APPENDIX A.9 BLENHEIM SHOPPING CENTRE COMMITTEE REPORT

Committee Date	5 th March 2024	
Address	Blenheim Shopping Centre High Street Penge London SE20 8RW	
Application number	23/00178/FULL1	Officer Agnieszka Nowak-John
Ward	Penge and Cator	
Proposal (Summary)	Phased development including demolition of existing buildings and erection of four blocks to facilitate a mixed-use development providing up to 230 dwellings, up to 2,714sqm of commercial/town centre floorspace and associated communal amenity space and play space, cycle parking, refuse storage and plant space in four buildings ranging between 3 and 16 storeys. Provision of public realm and new pocket park at ground floor with associated landscaping improvements. Provision of 24 commercial car parking spaces and 8 blue badge spaces for the residential accommodation.	
Applicant	Agent	
Hadley Penge LLP	Rolfe Judd Planning Ltd	
Reason for referral to committee	Major Development 20+ new dwellings	Councillor call in No

Fig. 6.4.3 Previous and amended Massing (Planning Addendum Report).

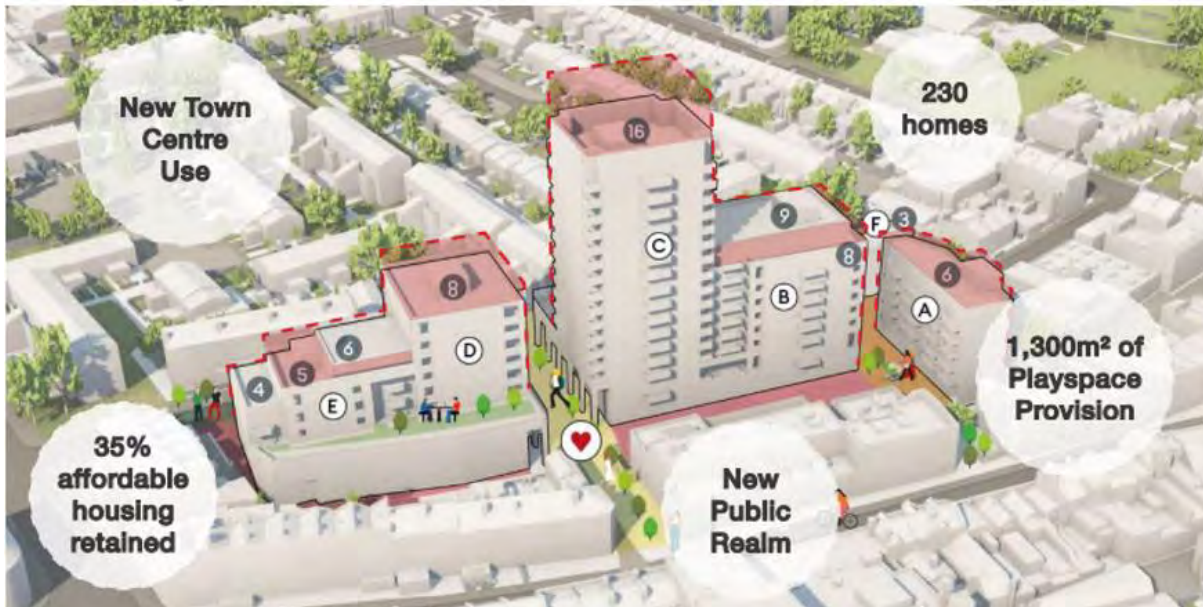
6.4.21 The HTVIA Addendum View 18 illustrates how the visual impact of the 9th floor setback element would not be too dissimilar to the full storey initially proposed – due to the minimal extent of the setback. As a result, the extent to which the revised scale/height of Block B would be ‘read’ at street level and/or result in a reduced townscape impact is considered to be minimal – this is evident when comparing the previously submitted and revised elevations and HTVIA Addendum views (Fig.6.4.2 below).

6.4.22 The proposed use of coloured metal cladding for the treatment of the 9th floor 'setback' on Block B to 'lessen its visual prominence' (Fig. 6.4.3) is questionable. Given the minimal setback provided, it is considered that the use of a different material may have the opposite effect to that which is intended – i.e. increasing the visual prominence and drawing attention to the top floor element of the building (Fig. 6.4.2 and Fig 6.4.3).
